Facility: <u>Surry</u>		Date of Examination: <u>8/23/2021</u>
Examination Level: RO <input checked="" type="checkbox"/> SRO <input type="checkbox"/>		Operating Test Number: <u>SR2021-301</u>
Administrative Topic (see Note)	Type Code*	Describe activity to be performed
Conduct of Operations	R,M	Perform manual Calorimetric <i>(1-OPT-RX-003, Sections 6.1 and 6.2 and Attachment 3)</i>
Conduct of Operations	R,N	Determine Core Crew Requirements <i>(OP-AA-100, Attachment 2)</i>
Equipment Control	R,D	Determine Tagout Boundaries <i>(OP-AA-200, 11448-FE-1K, 11448-FM-124A SH2) (Bank JPM from Surry 2010 exam)</i>
Radiation Control	R,M	Verify RWP adequate <i>(Rad Work Permit, VPAP-2101 Section 6.3)</i> <i>(Modified JPM from Surry 2009 exam)</i>
Emergency Plan		
NOTE: All items (five total) are required for SROs. RO applicants require only four items unless they are retaking only the administrative topics (which would require all five items).

**Surry RO Makeup JPM Summary**

Facility: Surry Date of Examination: 08/23/2021  
 Exam Level: RO  SRO-I  SRO-U  Operating Test No.: SR 2021-301

Facility: <b>Surry</b>		Exam Date: <b>August 2021</b>											
Admin JPMs	1 ADMIN Topic and K/A	2 LOD (1-5)

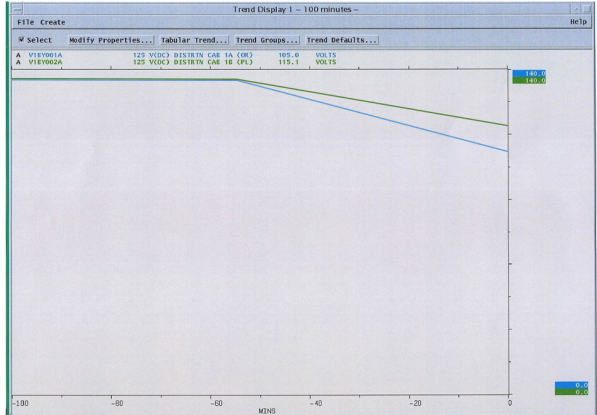
Q#	1. LOK (F/H)	2. LOD (1-5)	3. Psychometric Flaws					4. Job Content Flaws				5. Other		6. Source B/M/N	7. Status U/E/S	8. Explanation
			Stem Focus	Cues	T/F	Cred. Dist.	Partial	Job-Link	Minutia	#/units	Backward	Q=K/A	SRO Only			
6	H	2	x	x										N	E	<p>SAMPLE QUESTION REC'D 10-7-2020</p> <p>T1G1 025 (Loss of RHR) AA1.18 (operate/monitor LPI header x-connect valve controller &amp; indicators)</p> <p>8-21-2020: Replaced K/A because RHR/LHSI Pumps are different piping/pumps and no x-connect exists. New K/A:</p> <p>T1G1 025 (Loss of RHR) AA1.10 (operate/monitor LPI pump suction valve &amp; discharge indicators as applies to Loss of RHR)</p> <ol style="list-style-type: none"> <li>1. Stem Focus: From the stem conditions, it's unclear how Attachment 6 was reached in AP-27. Was Attachment 6 required by reaching Step 27? The sentence in Current Conditions ("<i>The RHR system was heavily damaged and is unable to provide cooling</i>") is vague and may preclude using Attachment 6. Was there also a RCS inventory issue; stem doesn't say? Need to trace out how Attachment 6 was arrived at in AP-27, then include stem conditions to match.</li> <li>2. Cues: The RCS pressure provided in the stem (below LSHI shutoff head), as well as the question layout for testing the same flow path required during an SI auto-actuation may provide cues that preclude testing the procedure required actions. In order to ensure overall RO written exam balance of coverage, for Tier 1 test items, ensure the test item tests required actions in the abnormal/emergency procedure or abnormal alarm procedure;</li> <li>3. Three column format is not needed; the 1<sup>st</sup> and 2<sup>nd</sup> columns could be combined to solely test whether 1862A or 1115B/D is required. In general, three-column format is not useful in four-choice questions.</li> </ol> <p>To resolve Comments #1, #2, and #3 above, consider the following slimmed down version:</p> <p><i>WOOTF completes both statements in accordance with 1-AP-27.00, Loss of Decay Heat Removal, Attachment 6, Forced Feed Cooling?</i></p> <p><i>The _____ leg is the preferred injection path. [hot vs cold]</i></p> <p><i>LSHI Pump flow is required to be limited to less than _____ gpm. [3000 vs 440].</i></p> <p>This slimmed down version hits the K/A because the pump flow is monitored on a discharge indicator; the suction valve piece is indirectly being tested via the injection path. All the cues are gone, just testing the procedure requirements.</p>
